## ANTUNOVICH ASSOCIATES

### MEMORANDUM

**SUBJECT:** 1900 Half Street, SW: Floodplain Mitigation Alternative Construction Methods

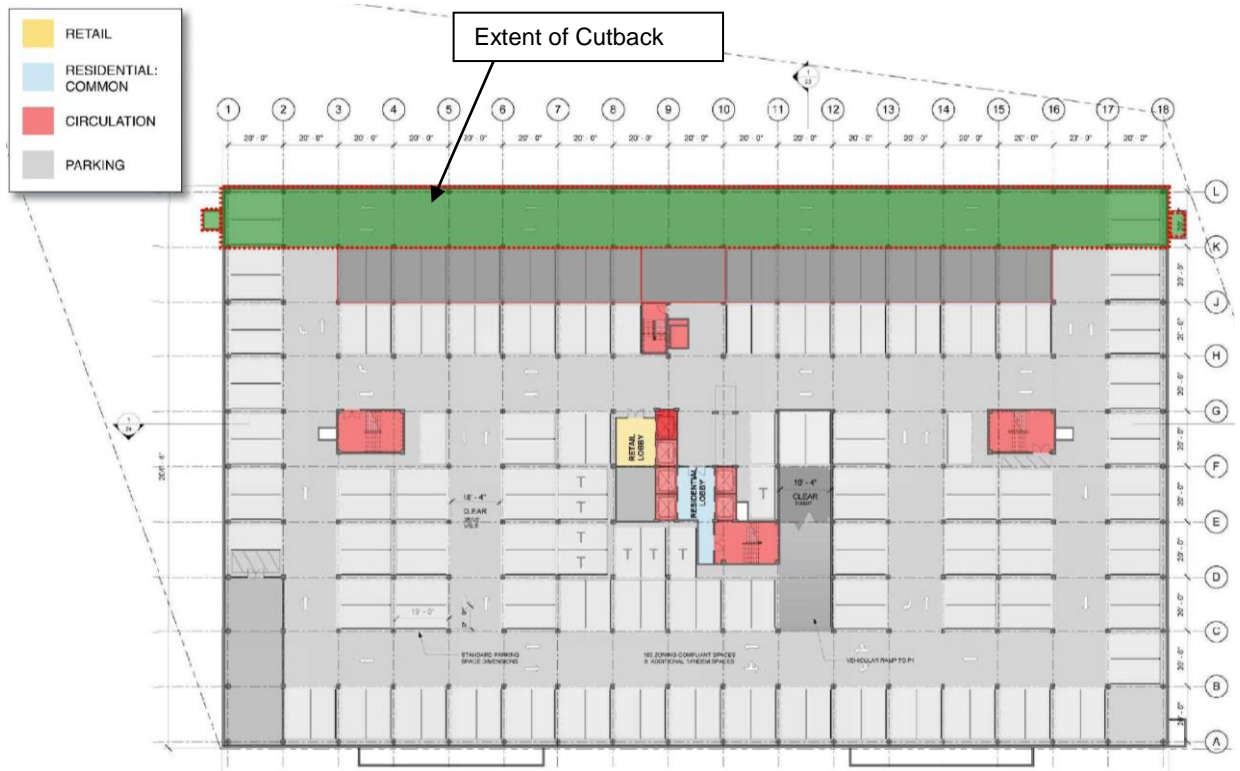
1. It will be a challenging task to cut back the existing building along the entire east side in order to excavate to the bottom of the lowest level. Since the building is situated close to the shoreline at its southeast corner, deeper excavation and demolition work will result in more damage to the site and its shoreline.
2. Approximately 514 cubic yards of existing soil would have to be excavated to reach the bottom of the building. Approximately 2,165 cubic yards of fill would be needed to infill the void after cutting back the building. Preliminary estimated fill needed for the Riverwalk construction is 1,047 cubic yards.
